HM/B-22:133 and A-24:93 14 Belvidere Lot Severance Application

**Re: Submissions on behalf of Marie Frances Theresa Di Silvestro
Committee of Adjustment (the “Committee”)
Application Nos. HM/B-22:133 & A-24:93 (the “Applications”)
14 Belvidere Avenue, City of Hamilton (the “Subject Property”)**

RE: Application A-24:93 for variances at 14 Belvidere

Figure 1: Excerpt of Tree Inventory Map 3

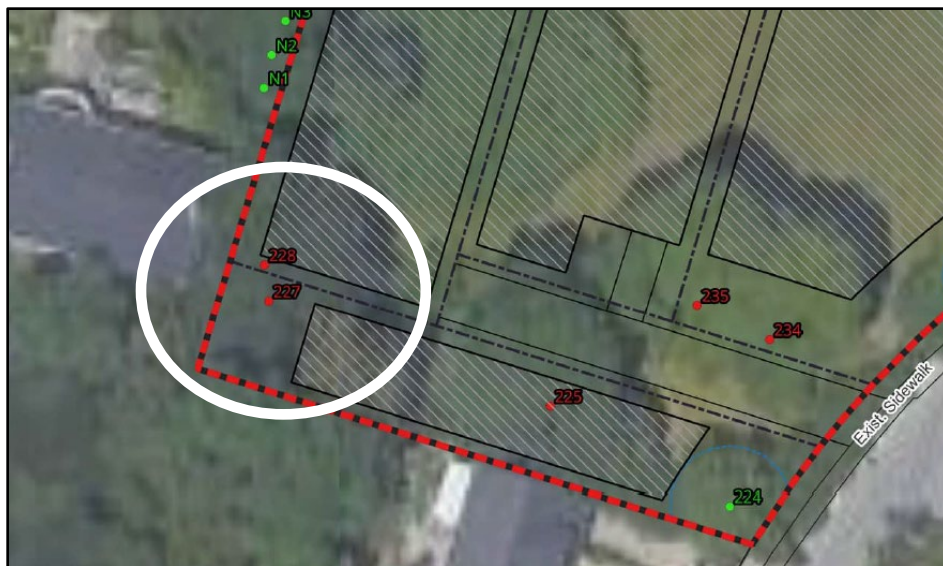
We have reviewed the Applicant’s Tree Preservation Plan to the best of our ability. It confirms that two trees need to be removed near the common boundary of the Di Silvestro Property and the Subject Property. One tree, No. 227, is a Norway Maple of 70 cm at diameter breast height and is the second largest tree on the Subject Property. The other tree, No. 228, is a Black Locust of 60 cm at diameter breast height and is also a larger tree. The location of both trees is shown circled below.

These two trees are healthy. According to the Tree Preservation Plan they have good trunk integrity, canopy structure, and canopy vigour. The reason they are being removed is, “due to direct conflict with the proposed home locations”.

Figure 2: Excerpt of Tree Inventory Map 3
(north-east corner of the Subject Property)

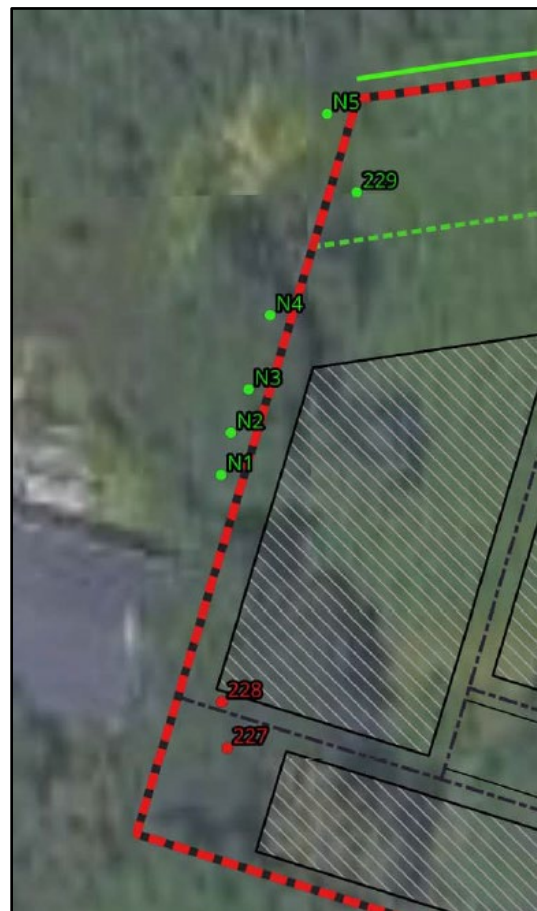
The Tree Protection Plan identifies five trees that are near the common boundary, but on the Di Silvestro Property. These five trees are labelled N1 to N5 as shown below.

The Tree Protection Plan does not discuss the impacts of the proposed development on trees N1 to N4. However, it does state, “[p]rotection requirements for trees located on the neighbouring property (N1 to N4) will be determined through an agreement with the neighbour”. As we understand it, no negative impacts are anticipated for tree N5 given its distance from the development site.

We wish to be very clear. The protection requirements for boundary trees N1 to N4 have not been discussed with Mrs. Di Silvestro. There is no agreement in place.

The Applicant shall provide a copy of the agreement entered into with the owner of 7 Harbourview regarding the protection of trees N1, N2, N3, and N4, as required by the Tree Protection Plan prepared by GeoProcess Research Associates dated March 5, 2024.

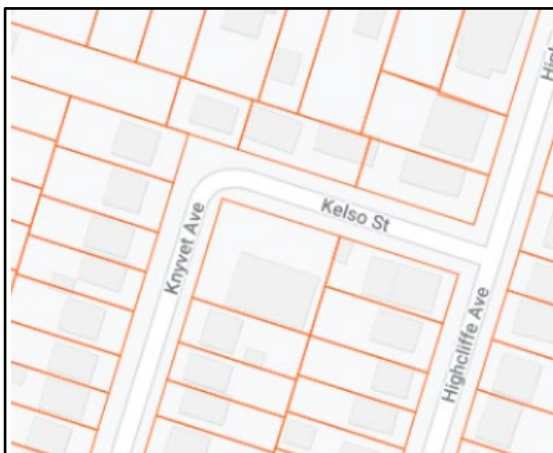
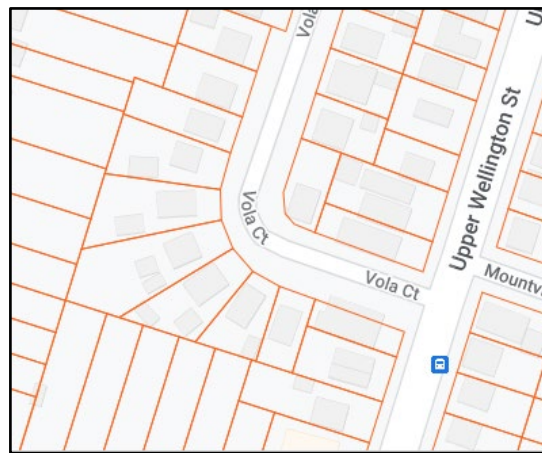
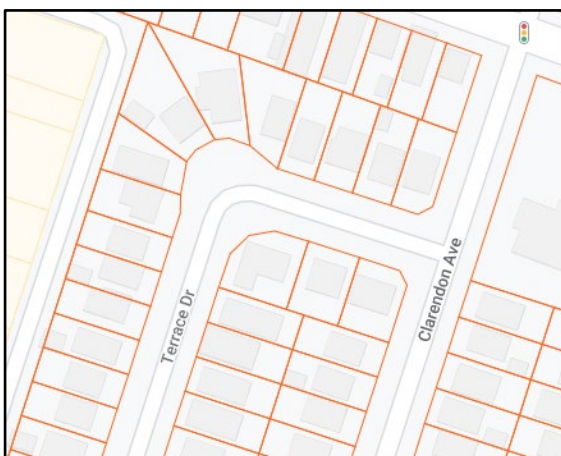
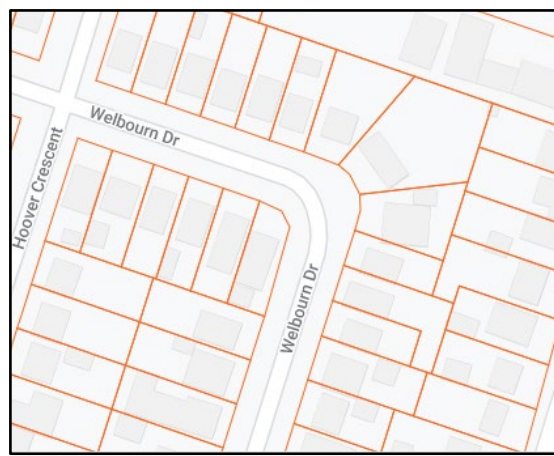
In our view, the better comparison is to other lots on road bends in the neighbourhood. As can be seen below, lots under such circumstances are street-oriented and do not gain access through an extended driveway. Accordingly, the proposed lotting scheme is not in character with the neighbourhood. Furthermore, the lotting scheme does not reflect good design as required by policy B.2.4 of the Official Plan, since Lot 2 is dependant on Lot 3 for access.
